DEPARTMENT OF THE AIR FORCE
AIR FORCE CIVIL ENGINEER CENTER

Subject: Response to WAFB – ADEQ Comments – ST012 – Discussion toward Extending Steam Enhanced Extraction, Bioremediation (EBR) Transition, Former Williams Air Force Based, Mesa, Arizona.

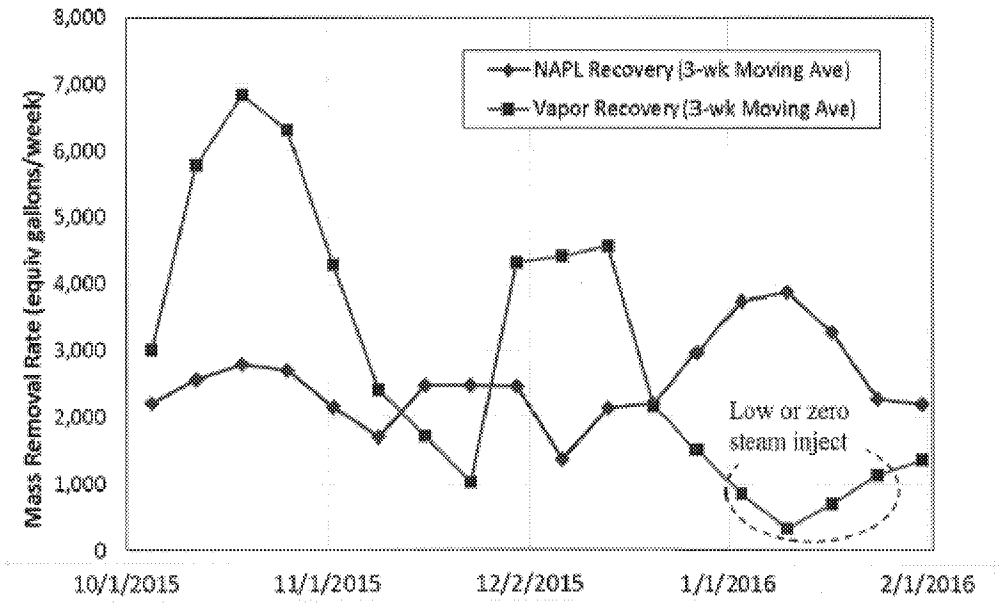
ADEQ asserts the mass removal criteria for transition to EBR has not been achieved. Data from weekly progress reports were plotted to show the average gallons of NAPL recovered each week starting in October 2015. Equivalent gallons of NAPL recovered in the vapor phase were also plotted and the results are illustrated below. The NAPL recovery rate (red) has not decayed over the last four months, consistently averages over 2,000 gallons per week, and no indication of decay is evident. The vapor recovery rate (blue) illustrates a general decay; however, the rate dropped when the steam injection was lowered and ceased at the beginning of January. This drop in vapor recovery with steam cessation indicates significant mass continues to be recovered from within the TTZ by steam injection and that mass recovery rates continue to be related to steam injection.

As stated in the Work Plan, the actual site specific removal rate curve will be evaluated to confirm or adjust the appropriateness of 10% of maximum to represent a condition of diminishing returns. The plan further states, continued operation below the 10 percent of peak removal rate may be implemented depending on the significance of continued mass removal, the status of Contaminant of Concern (COC) concentrations (e.g., benzene) in extracted fluids, and the need/ability for EBR to achieve further degradation based on data collected during the EBR field test.

Response: The mass removal data as presented in the weekly reports can create confusion for this type of analysis. Vapor mass removal includes both wellfield vapor mass as well as volatilized contamination from liquid treatment systems (tank vents and air stripper off gas). The turbulent flow encountered in the extraction system may also promote contaminant phase changes between the extraction wells and the treatment system. Vapor mass removal from the weekly reports can be affected by the latest available laboratory data. Vapor mass removal rates are calculated in the weekly reports based on the most recent available laboratory data. When new data is received, vapor mass removal calculations are adjusted back to the sample date but mass removal totals in previous weekly reports are not corrected and reissued. Finally, NAPL removal in the weekly reports is based on the total NAPL transferred to the storage tanks during the week divided by seven days. When NAPL is apportioned equally between days since the previous transfer it results in a slightly different NAPL removal rate.

These combined factors introduce errors using the data from the weekly reports in as described in the comment. The information presented in the BCT calls and meetings are a better representation of mass removal for making the type of evaluations described in this comment. The actual mass removal calculation spreadsheet has been provided (email from Don Smallbeck to BCT members on 4 March 2016) with data and mass removal calculations through the end of February.

With respect to the consistency of mass removal over several months, the adjustments made to continue to improve mass removal have likely contributed to the slow overall change in mass removal rates. Also, pressure cycles prior to the January depressurization were not coordinated across all three zones simultaneously, which may have hidden some of the mass removal fluctuations during earlier pressure cycles.
